September 23, 2015

PROJECT:
**RESIDENTIAL LOWER FLOOR
CONVERSION & REMODEL**
615 HAIGHT AVENUE
ALAMEDA, CALIFORNIA

From: Melanie Snell <melaniesnell@gmail.com>
Sent: Tuesday, November 03, 2015 11:42 PM
To: Bao-Long Nguyen-Trong
Cc: Anh-Thu Nguyen; snelljoe1979@gmail.com
Subject: Re: Rear addition feedback

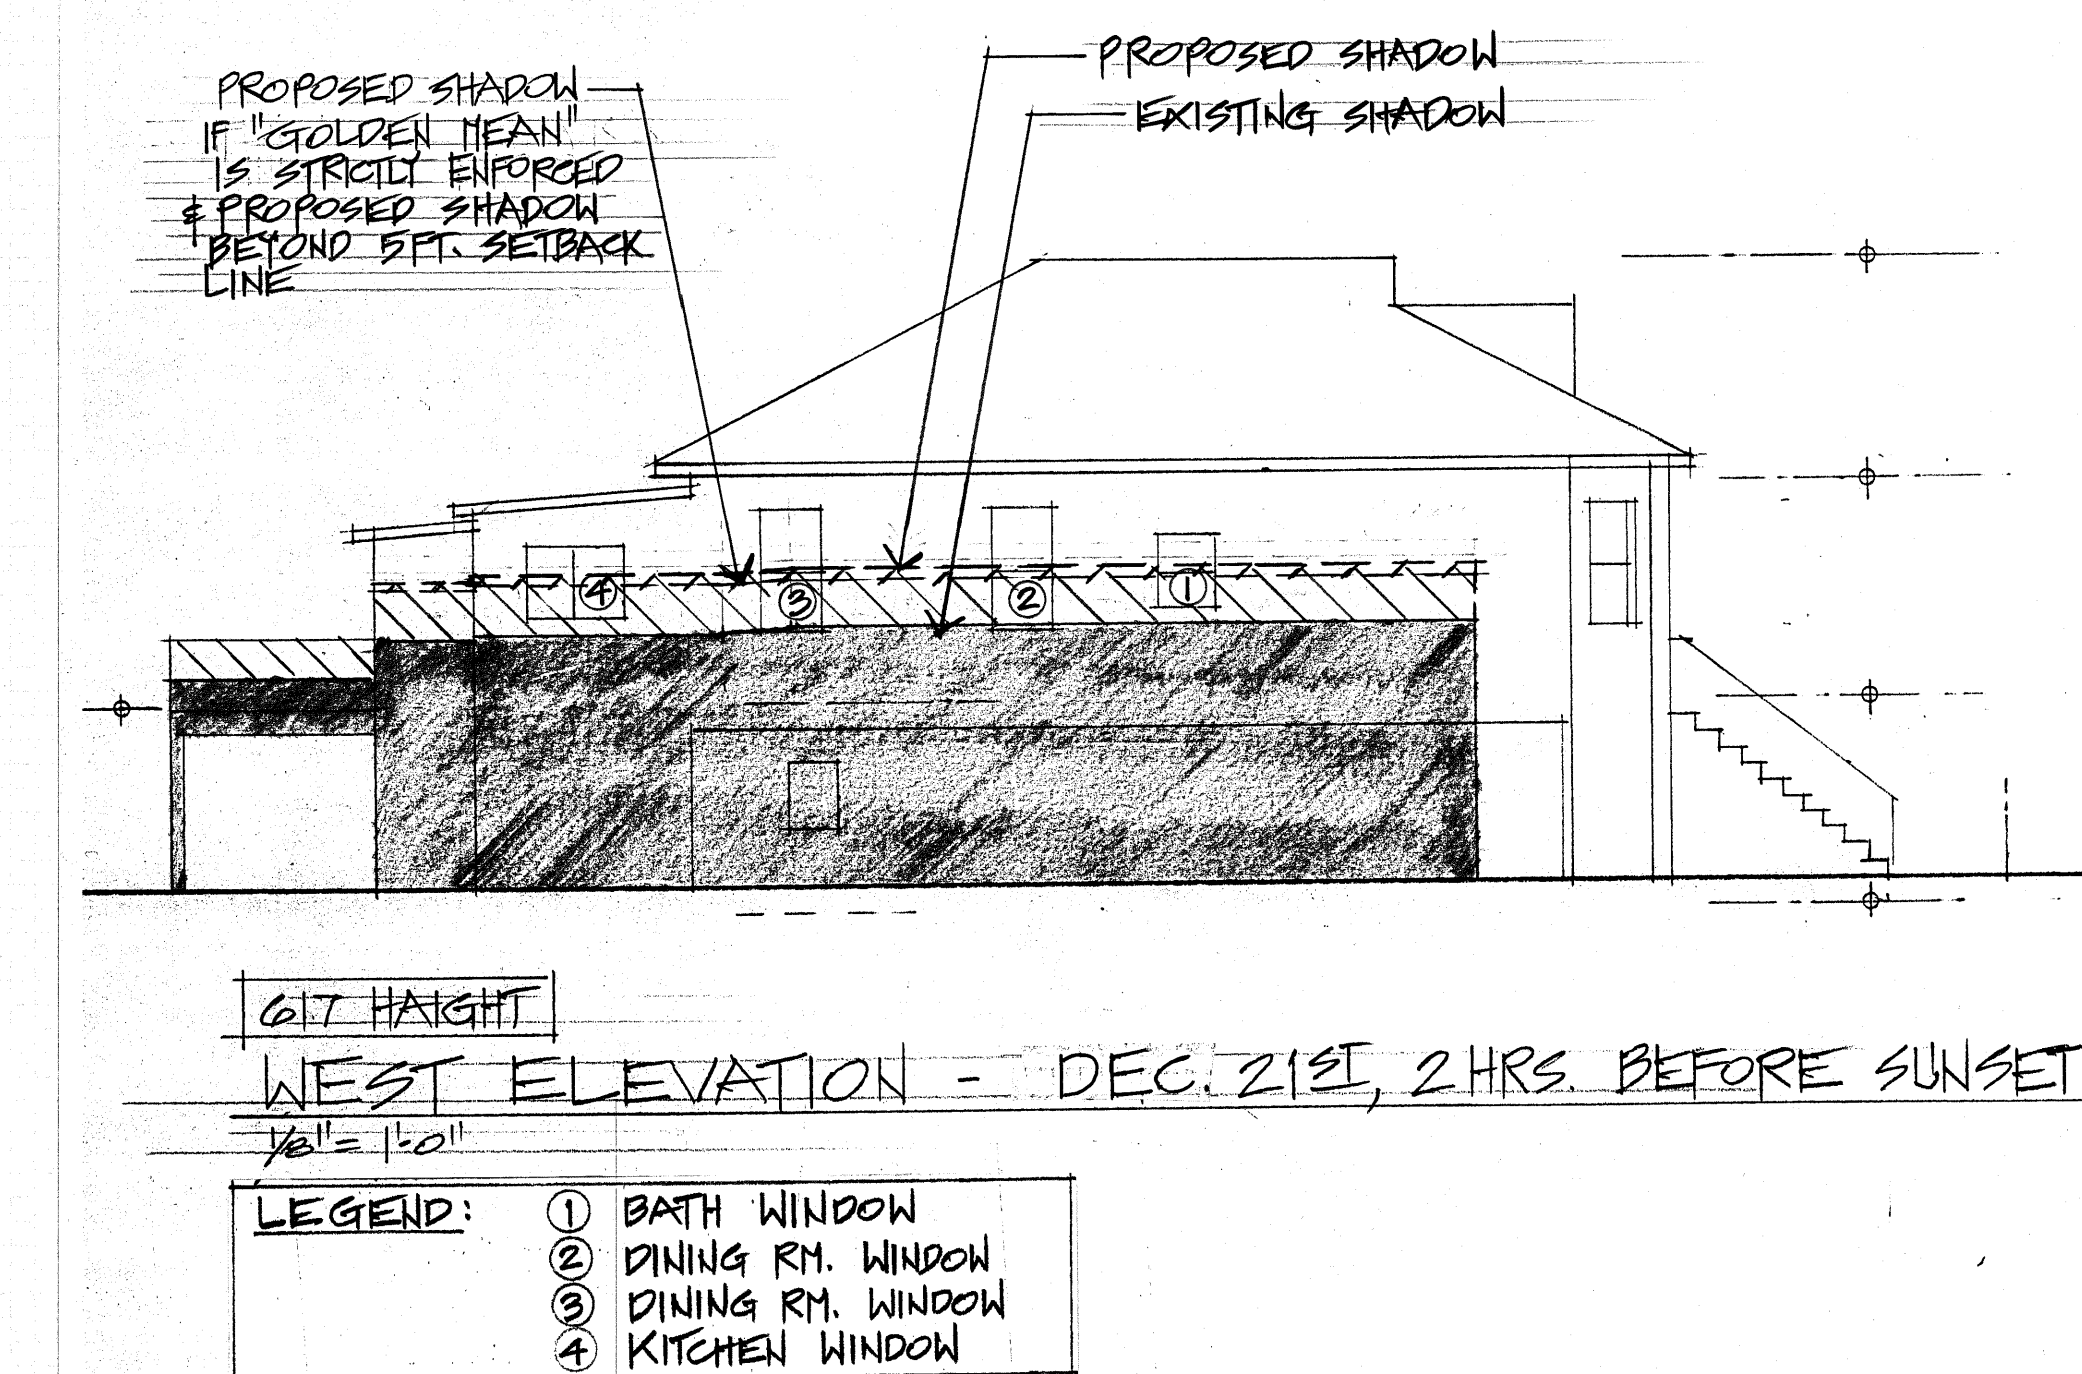
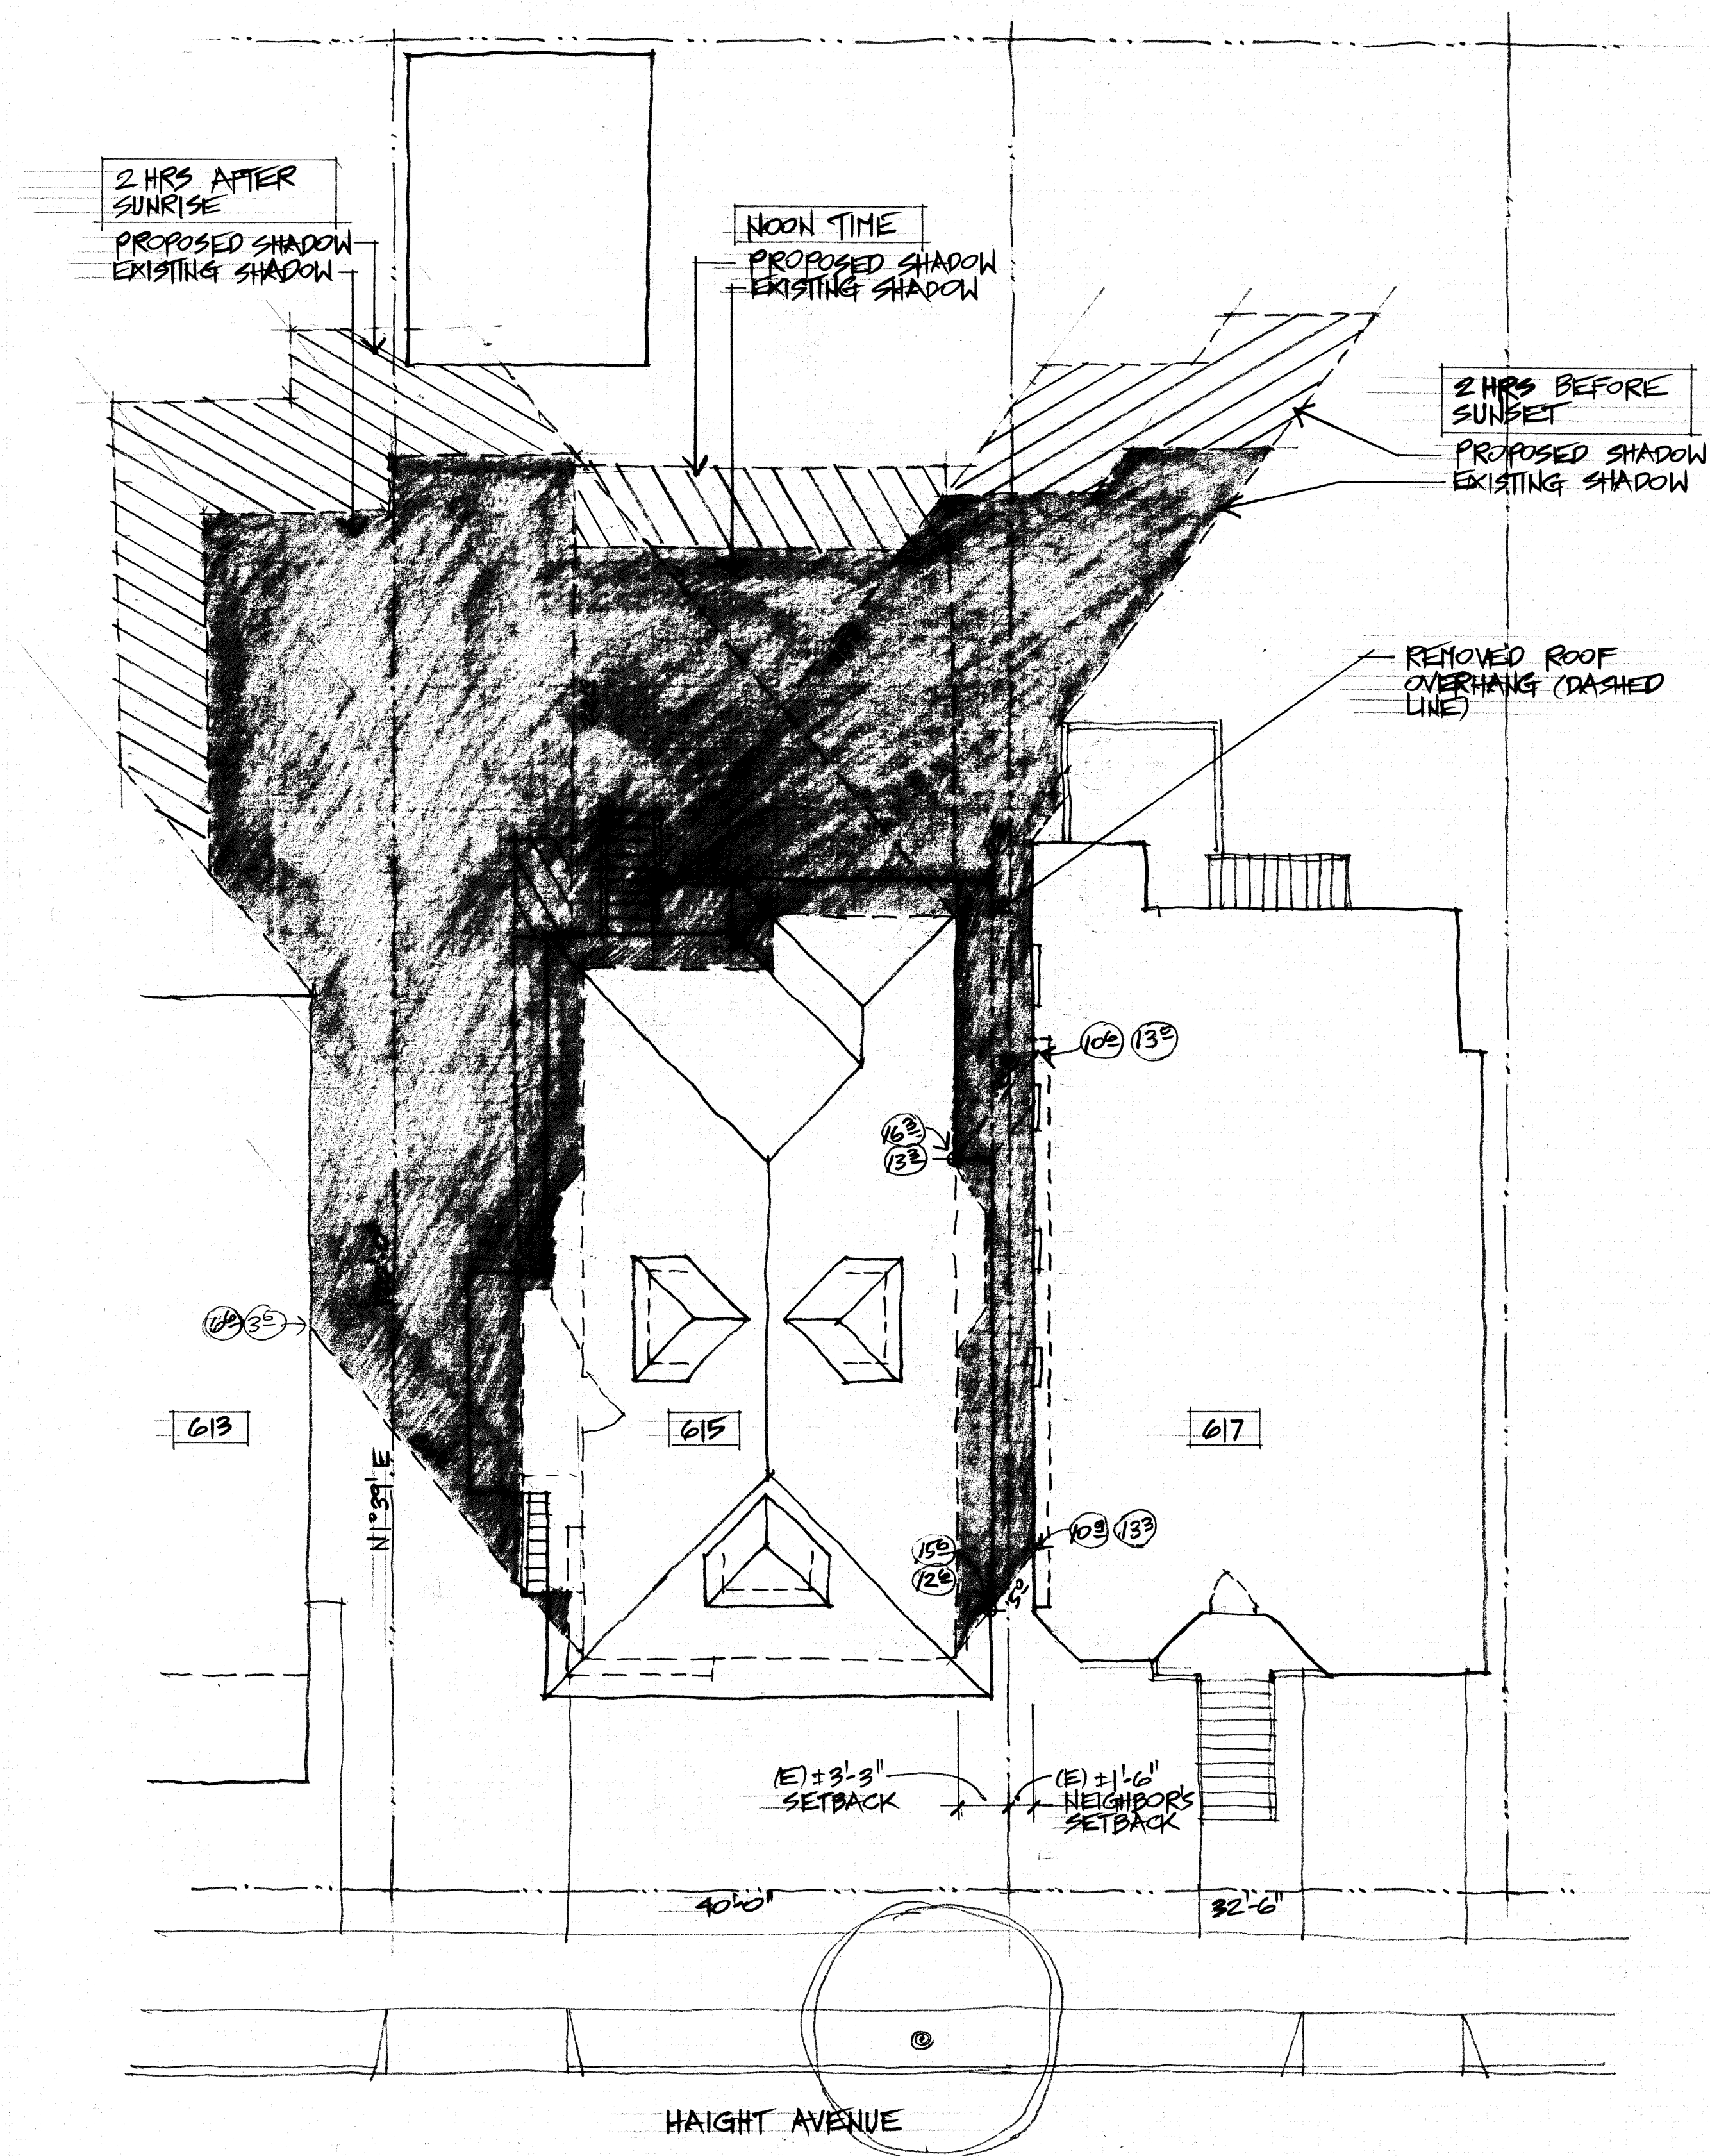
Upon reviewing the plans, one concern came up that I am hoping we can work out to everyone's satisfaction. In this new design, the stairwell stands on the existing structure and goes back 7'4". This results in the stairwell facing directly our last window on the West side and being close to the next window over to the South. With that configuration, the impacts would be about privacy, loss of view on the last window and shadow on both windows.

I am sure privacy is a concern for you as well and we would like to suggest installing obscure glass on the stairwell window. Moreover, we are a bit confused about its size. You mention in a previous email that the window would be a small one high above however the plans show a big window. In any case, we want to suggest a small window similar to the other ones on that side and level of the building on top of the obscure glass.

We understand your choice of the connection between the 1st level and 2nd level starting within existing structure. However, with this new design, the view from our last window would be completely obstructed. Moreover, there would be a shadow impact on both that last window and the one over to the South.

In order to minimize these impacts and maintain the spirit of your design, we would like to suggest aligning the South wall of the stairwell with the one of the master bedroom. This would reduce how much the stairwell goes back into the existing structure by 3'4". There would still be both a view and shadow impact on our last window but that would practically remove the impacts on the window South of it.

Our architect says that this can be done in various ways. The most obvious ones would be by shifting the East side of the expansion by that much and/or having the stairs turn left as you go up instead of turning right. In any case, we can have the architects discuss the technical details in a future meeting, maybe next week?

To this end, we are willing to agree to your request that we reduce the size of the window above the stairwell to match the other windows on the East side. Our architect explained that if we do this, the window will be a clerestory window above the stairwell and there will be no vantage point that would create any privacy concerns.

The second suggestion about moving the stairwell is more problematic, however. By agreeing to pursue a rear addition rather than increase the height of our home and build within the existing footprint, we are sacrificing a large portion of our yard. When discussing our proposal to build a rear addition with a couple of different local realtors, they both said that it will be important for us to maintain as much of our yard as possible. In order for us to accommodate your request, we would have to encroach even further into our backyard.

Furthermore, moving the stairwell back and then changing the orientation of the stairs which would be necessary has an impact on the rest of the floor plan both on the first and second floors. In addition to sacrificing our yard with this new proposal, we have also lost one additional bedroom and bathroom. Changing the orientation of the stairs jeopardizes the additional bedroom and bathroom that remain on the first floor.

We understand you to say that you are aware that your kitchen window will be impacted regardless of whether we move the stairway or not, and that you are trying to reduce the impact to the window immediately South of that. However, when we look carefully at our current proposal and how it aligns with your residence, it appears that our proposal as it stands does not directly affect that window to the South. Our architect originally designed a layout that had the stairs running from North to South along the Western wall. However, we realized that the roof necessary to cover this stairwell would have aligned with that dining room window, and he redesigned the layout to limit the impact to just one window. Unfortunately, we do not see a way to move the stairs again without sacrificing more of our yard or the additional bedrooms and bathrooms that remain.
